AGENDA FOR REGULAR MEETING VILLAGE OF TINLEY PARK PLAN COMMISSION

**ITEM #1 PUBLIC HEARING – DUNKIN’ DONUTS OUTLOT REDVELOPMENT
(TINLEY DOWNS PLAZA) – SPECIAL USE FOR PUD AND SITE
PLAN/ARCHITECTUAL APPROVAL**

PLAN COMMISSION STAFF REPORT

- Special Use for a PUD
- Site Plan &
Architectural Approval

LANDSCAPE

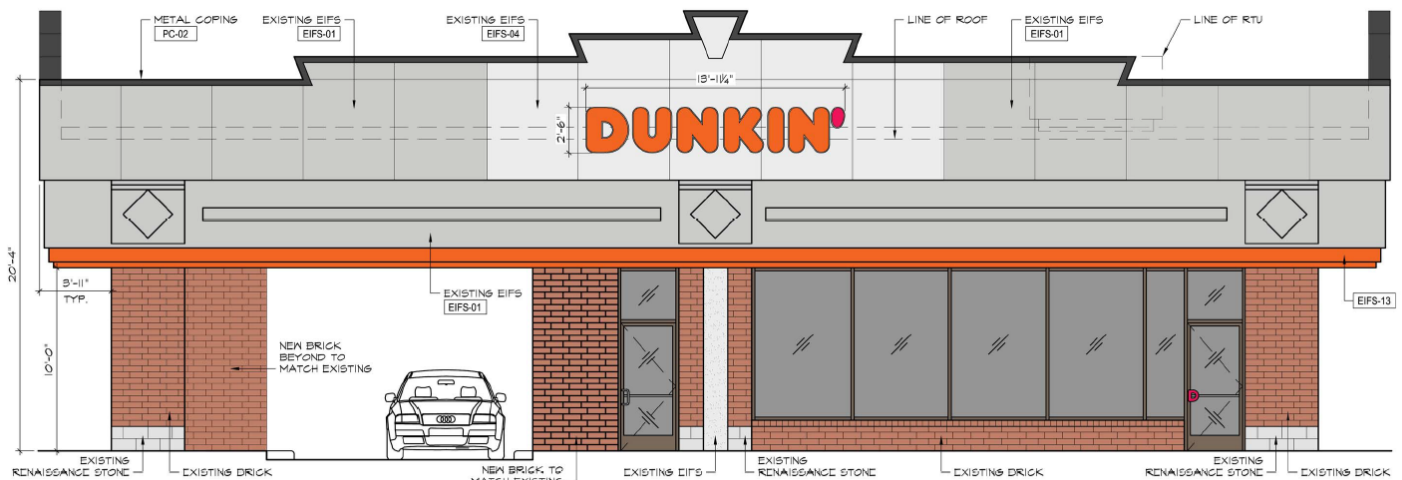
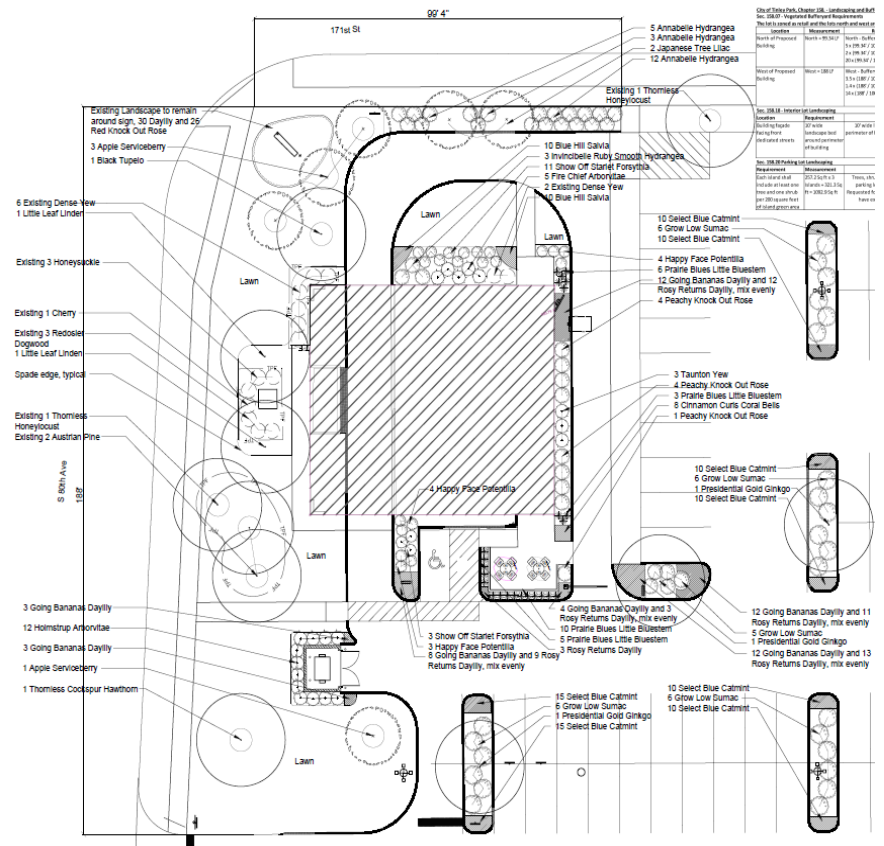
The landscaping in the overall center is mostly remaining the same. However, landscaping is being added where site plan changes are being made around the outlot building. Most notably, landscaping is being added at the 80th Avenue entrance and the new dumpster enclosure area. Landscaping is also being added to the four new parking lot islands. Landscaping is shown around the drive-thru lane that will help to prevent headlight glare to and from the drive-thru lane vehicles.

Open Item #6: Discuss the proposed landscape changes/improvements.

SITE PLAN

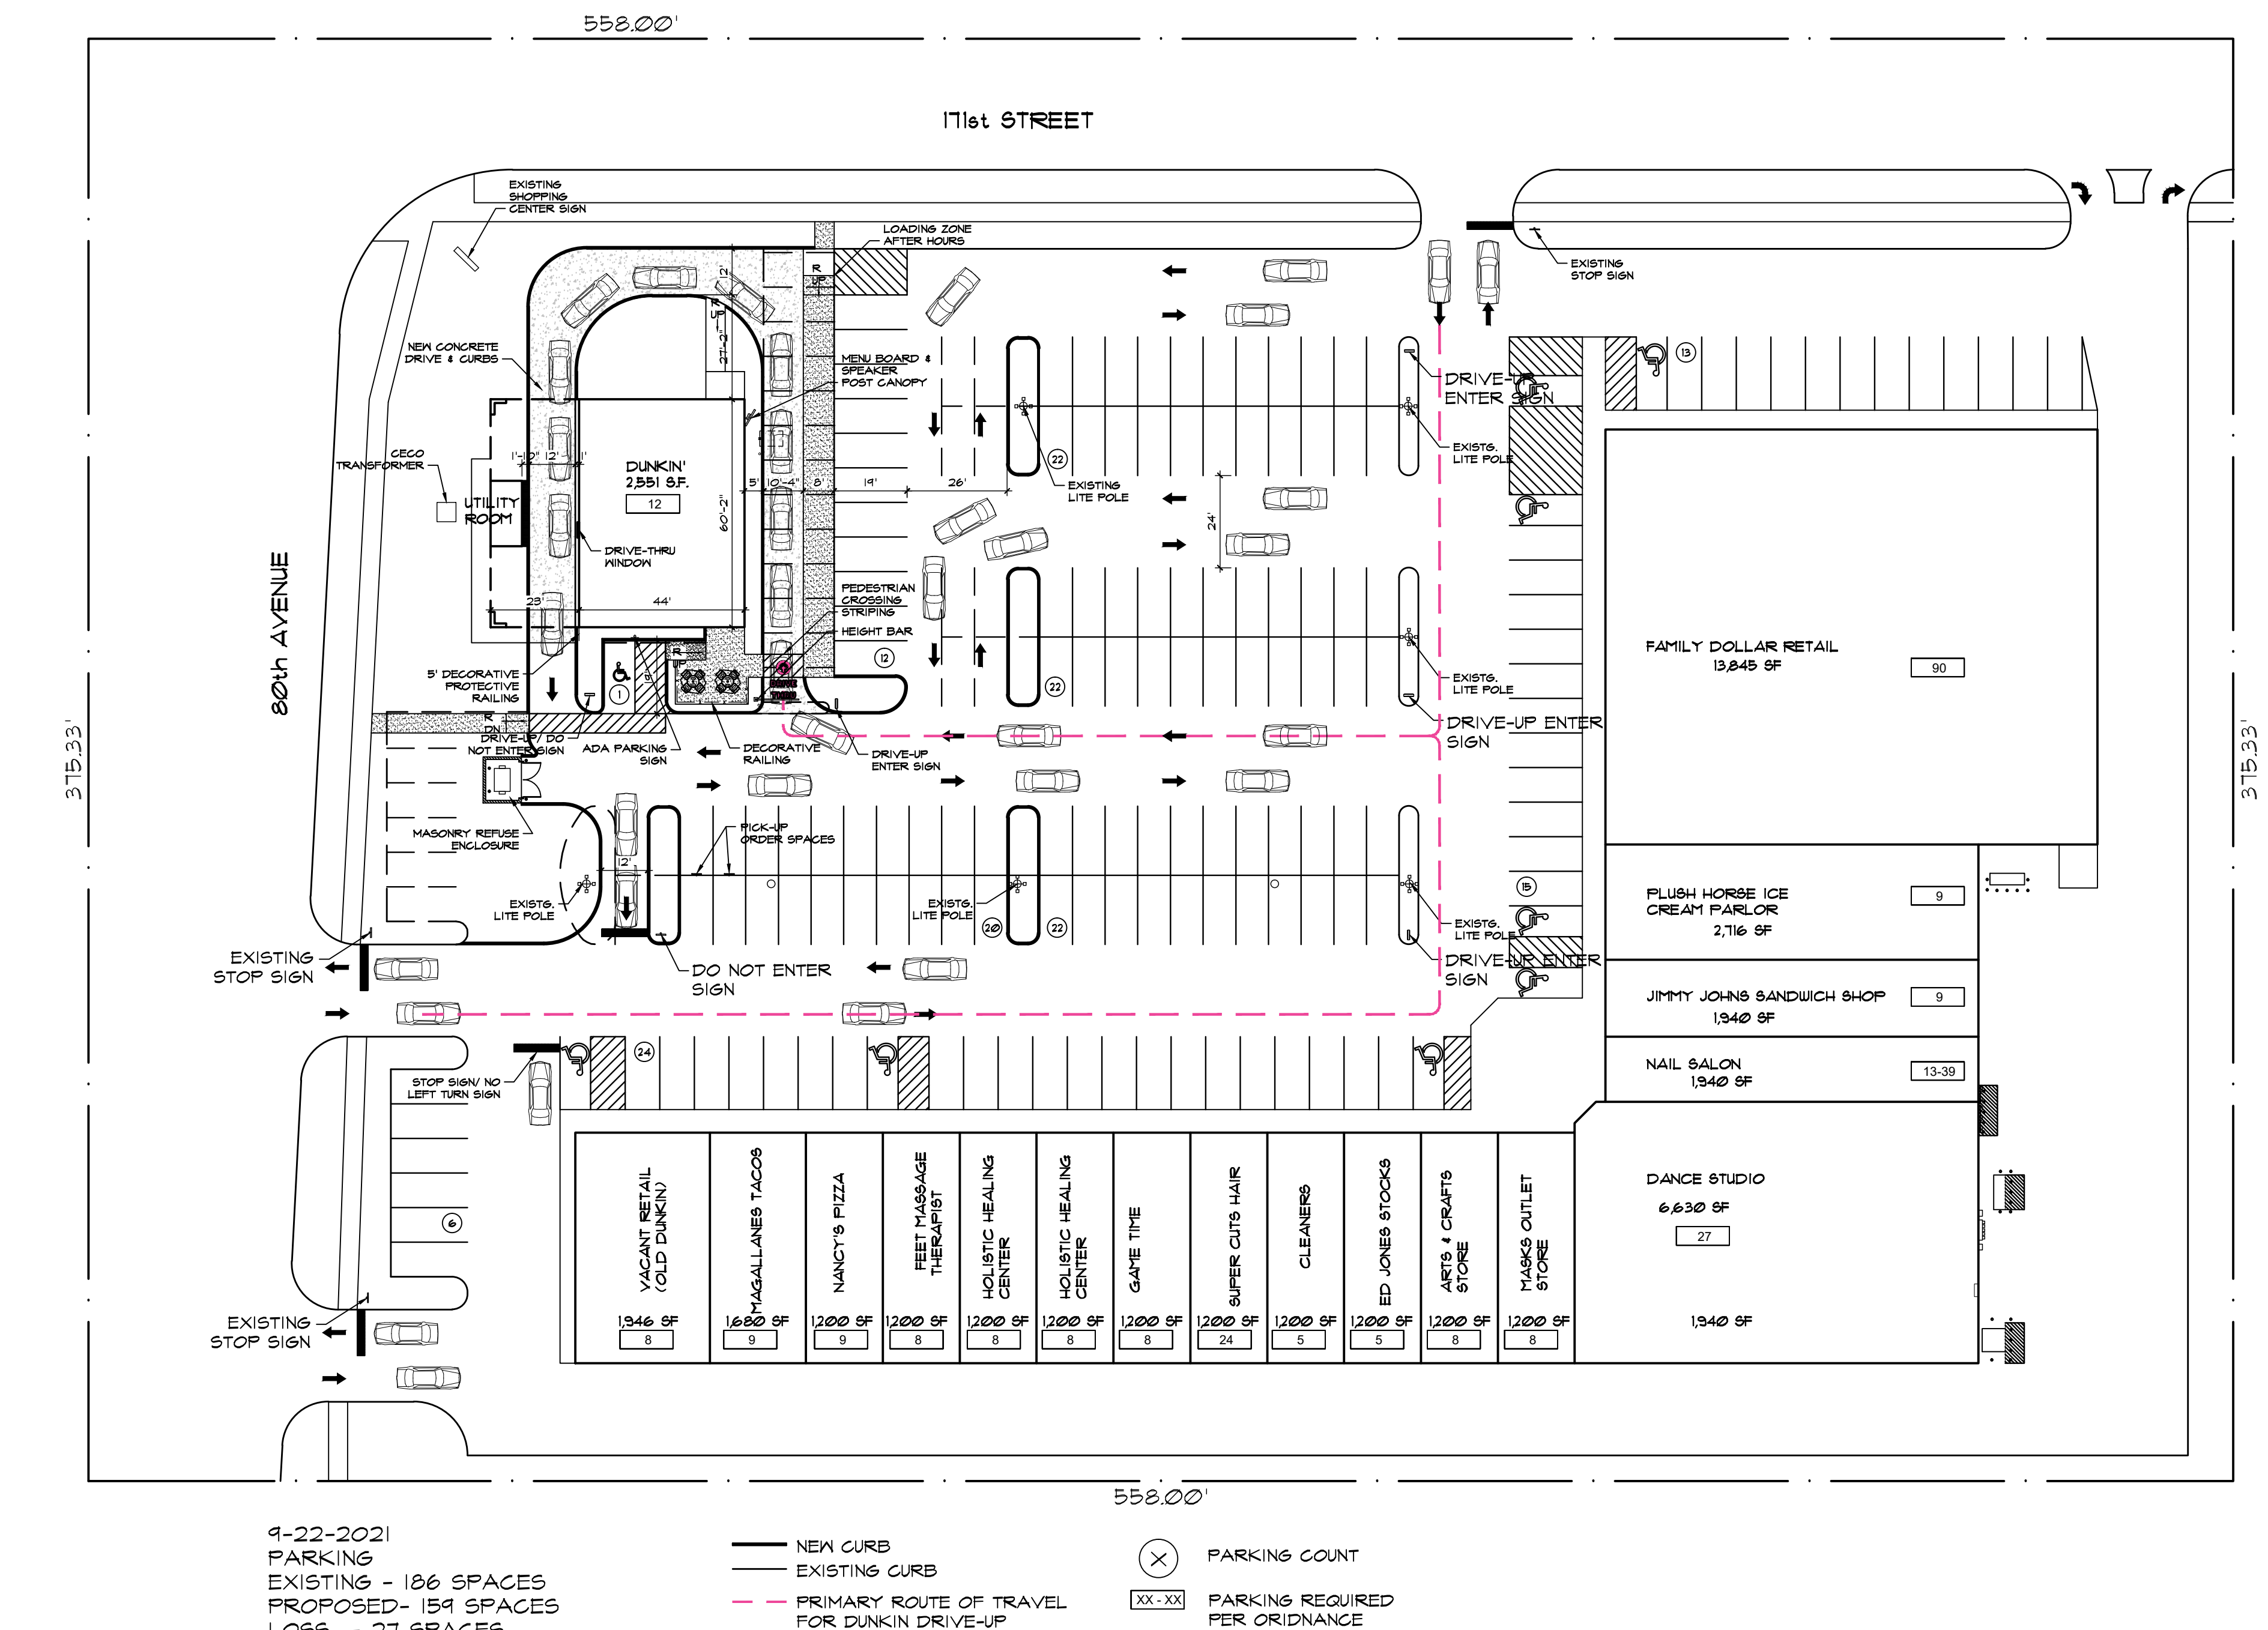
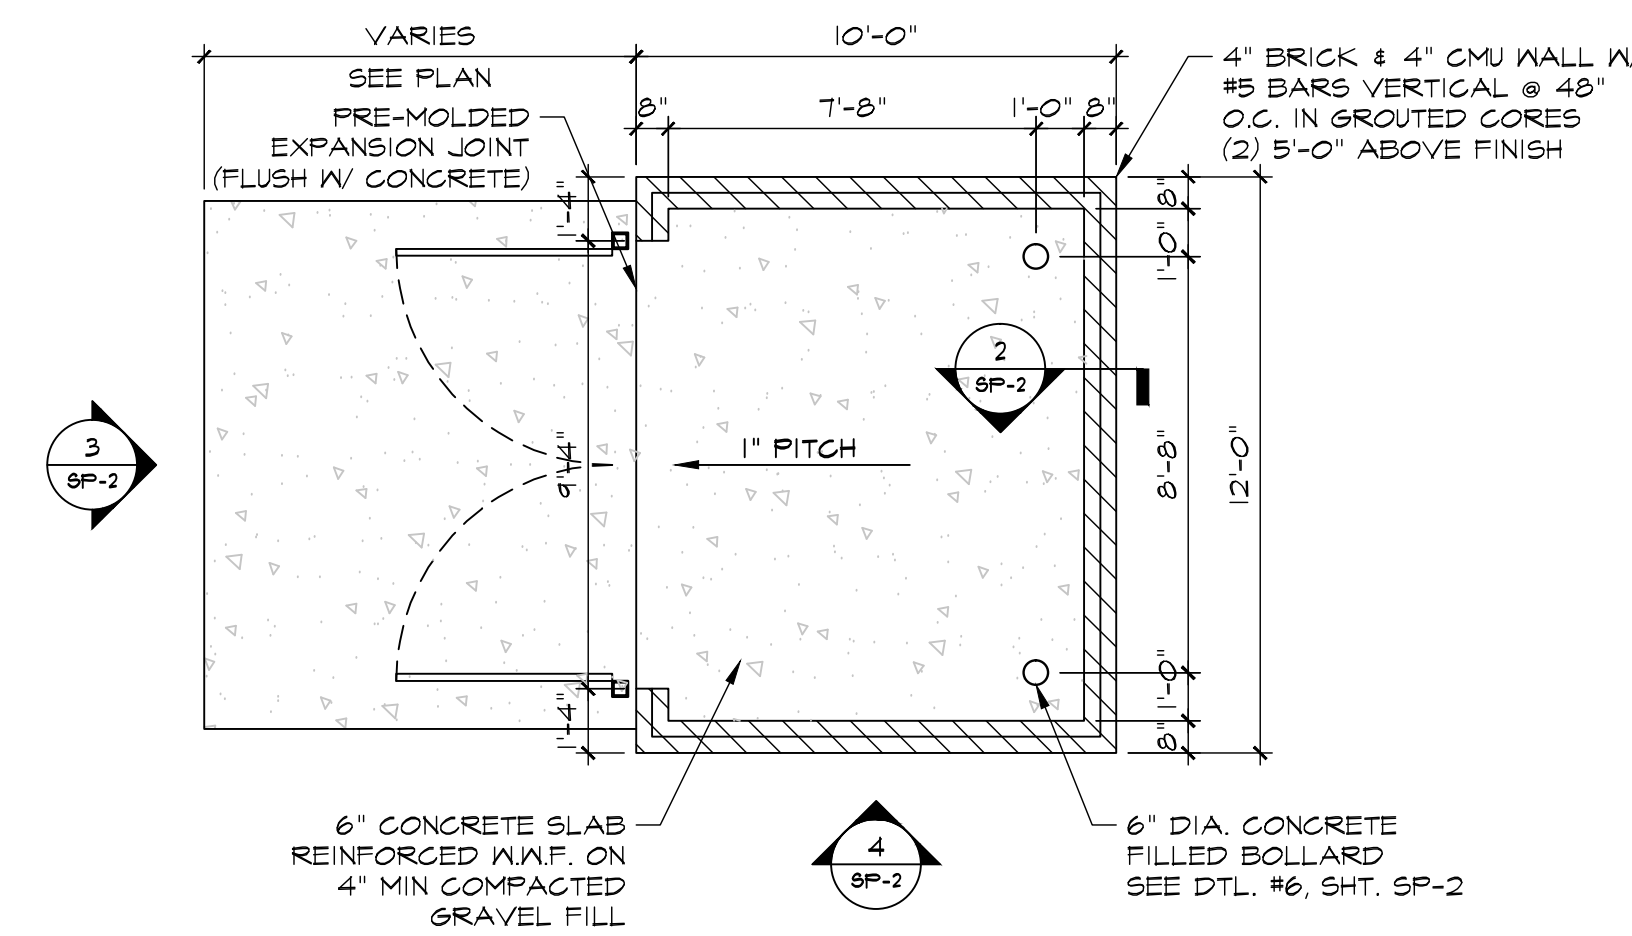
COMMISSIONER SHAW likes this design conceptually. It is unique and will add value. On the southwest corner, it wasn't clear that parking spaces were being removed. That looks good. Having trees along with the portion of the building both help screen the drive-thru itself. He asked if the trees will be planted at maturity.

COMMISSIONER MANI echoed Commissioner Shaw's comment on the chokepoint. He asked that if they could match the new median being created to what's there, and make it skinnier, so that it could be double-way. Possibly the trash enclosure could be shifted to create that opening. Otherwise, as one-way if you take 80th Avenue then you have to go all the way around and come back. People might drive between parked cars, creating a hazard. Making a larger opening would allow for people to go both ways.

COMMISSIONER LOSCUITO echoed Commissioner Gatto's point. The plan is to have it stack in the middle lane of the lot which is not an issue since the other businesses aren't open that early in the morning. He agrees with staff to remove the existing nonconforming signs. The new Dunkin location will be more exposed at the corner spot.

Overall circulation was noted as appropriate in keep vehicles from having conflict points or stacking into public streets. The commission recommended adding a railing or some way of preventing pedestrians from crossing by the drive-thru where there is a blind spot for vehicles and pedestrians to see each other. Plans were revised with this suggestion in mind.
